Service Bulletin No. 067

Turbocharger Wastegate Poppet Valve Replacement HET Part Number 477285-0002

Figure 2 - New Poppet Valve (HET P/N 477285-0002) with H1112 Date Code

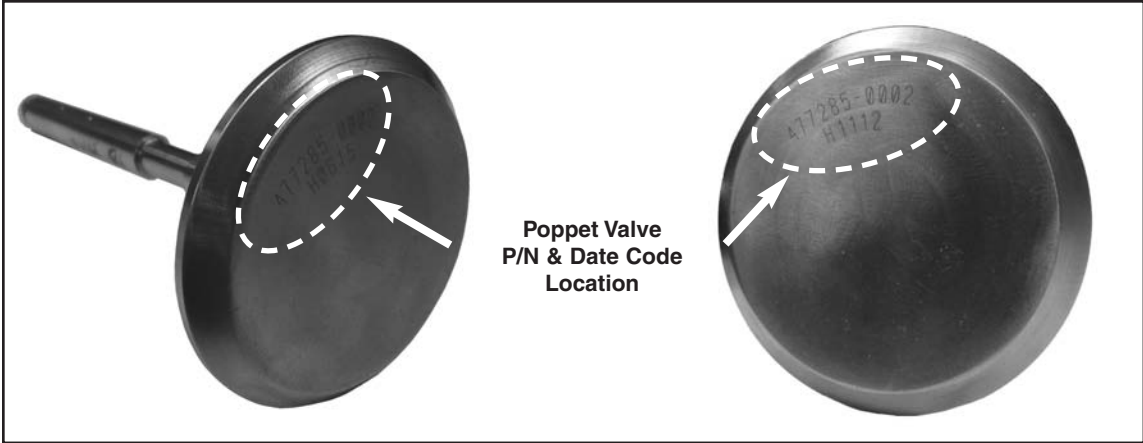
- (2) Inspect the face of the Poppet Valve for the affected date code (H1112) shown in Fig. 2:
 - (a) If the date code is H1112, continue to 3.C(1) or 3.C(4).
